Approach Slab Submittal #2, Approved 4-22-15.pdf

CONTRACTORS VISPE	Rev	Date	By	Description	PRECAST CONCRETE APPROACH SLAB SHOP DRAWINGS (SDI JOB #15801)		INSTALLER:	FABRICATOR:
	1	04/16/15	IBA	Changes per State Review	SUPERVISOR: E. Barendse	PROJECT NAME: Walden BR# 030-3(5)	J.A. McDonald, Inc. PO Box 132 Lyndon Center, VT 05850	193 INDUSTRIAL AVE. WILLISTON, VT 05495 Ph: (802) 658-0201
					DETAILER: I. ADAMS	PROJECT #: 030-3(5)		
					CHECKER: E. Barendse	LOCATION: Walden, VT	04/08/2015	SLAB_BAR_1
					ENGINEER: VT AOT			7_OF_10

AS #1 Details

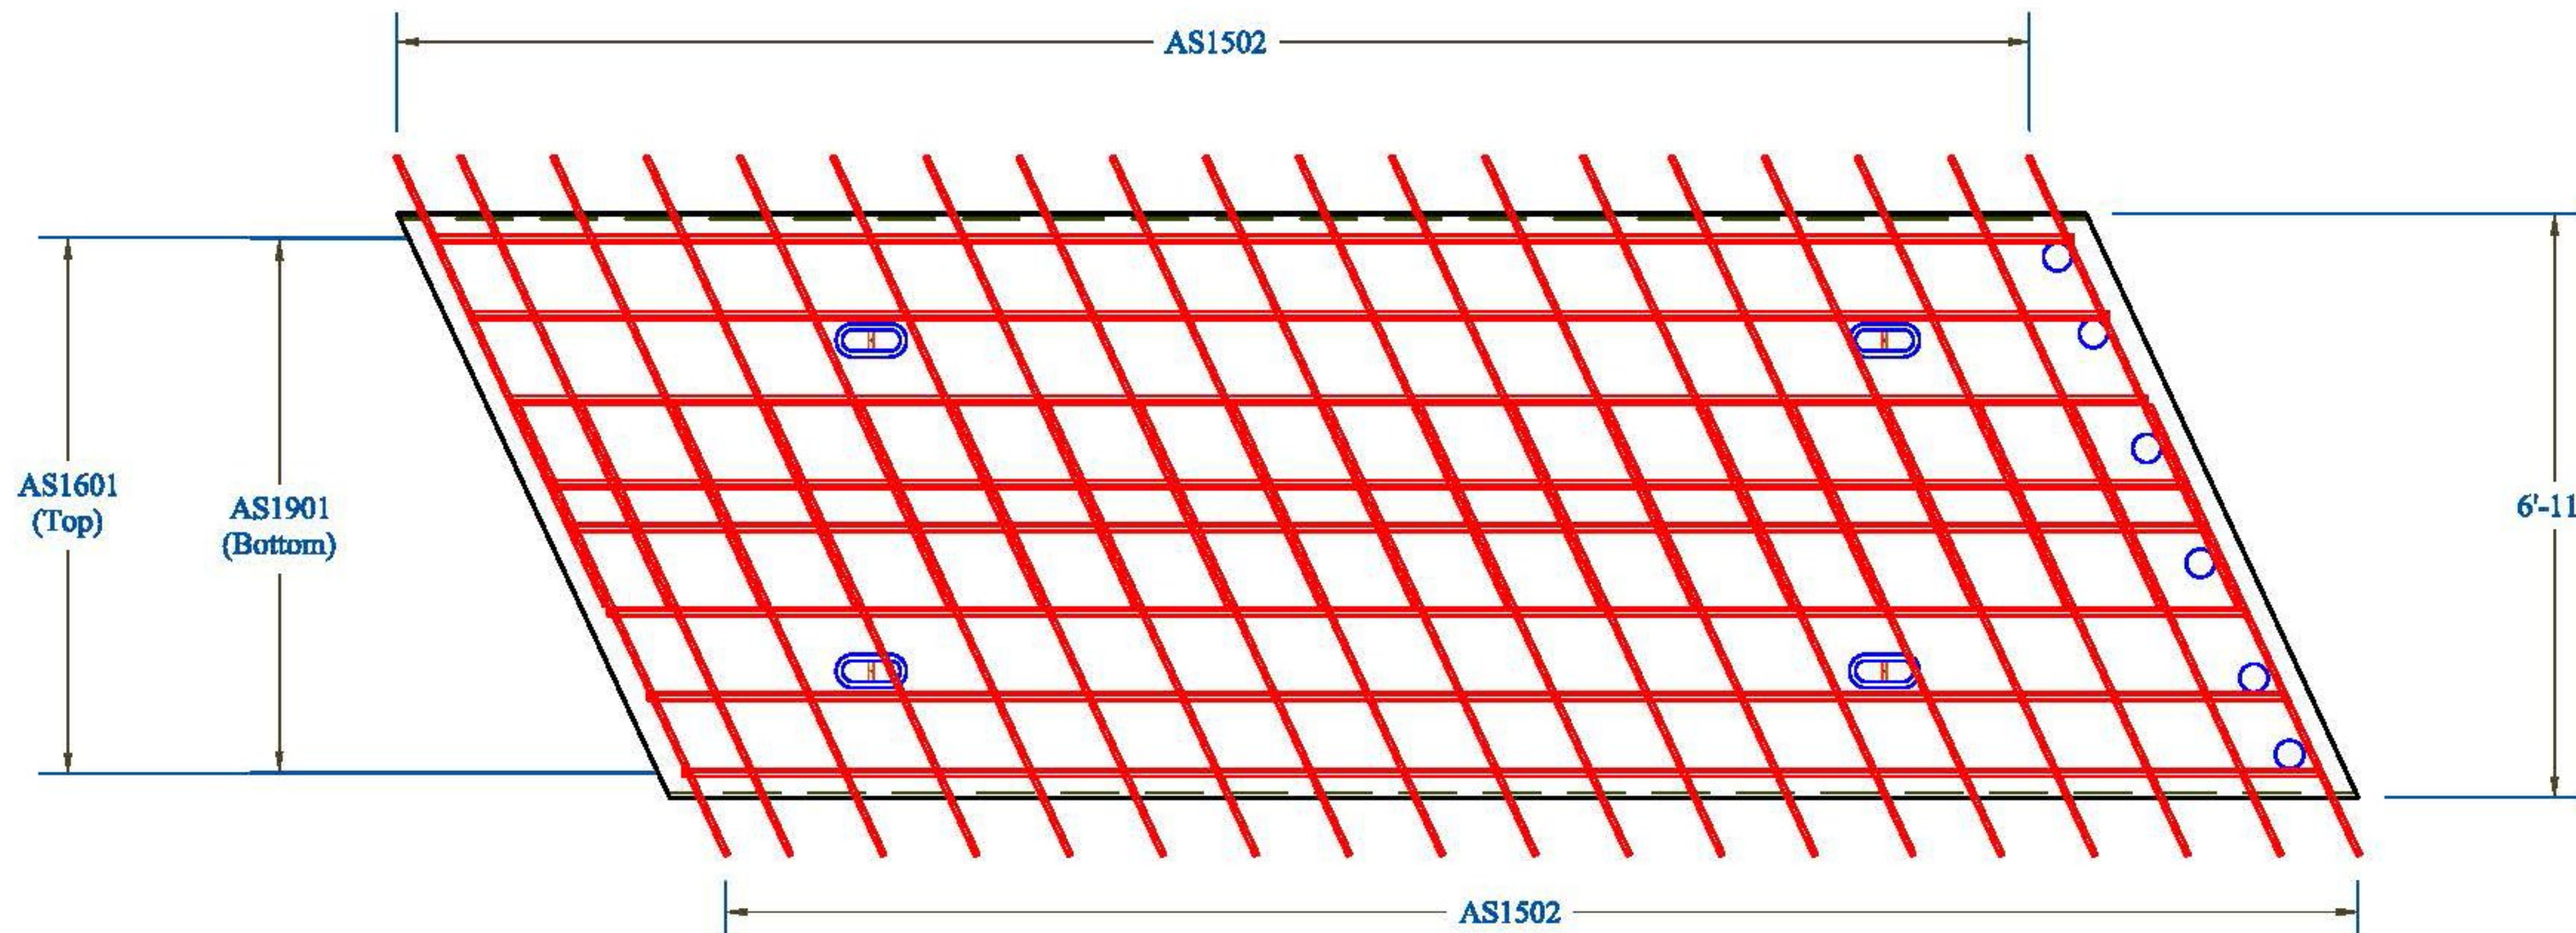
Check depth of lifting inserts to ensure they will not interfere with the rebar
